Follow Up Changes:

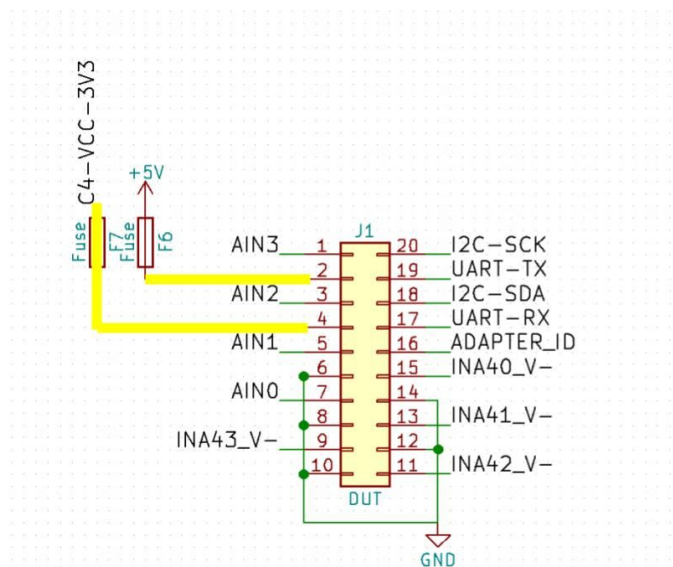
- 1) J17 needs to be flipped along its horizontal axis. For example, the pad for pin 1 should be where the pad for pin 2 is, and the pad for pin 2 should be where the pad for pin 1 is.
- 3) J23 needs to be flipped along its horizontal axis. For example, the pad for pin 1 should be where the pad for pin 2 is, and the pad for pin 2 should be where the pad for pin 1 is.
- 4) trace from F6, Pin 2 to J1, Pin 2 should increase in width. The trace width to match the 5V coming to the fuse.

Trace from J1 pin 4 through F7 to C4-VCC-3V3 should increase trace width. Trace width should match the C4-VCC-3V3 net trace width.

- 5) Corners of the PCB should be rounded
- 6) JP1-9 pads should be wired together. They are currently still not wired.
- 7) Add proto-area where indicated on the PCB. Proto-area should look like this:
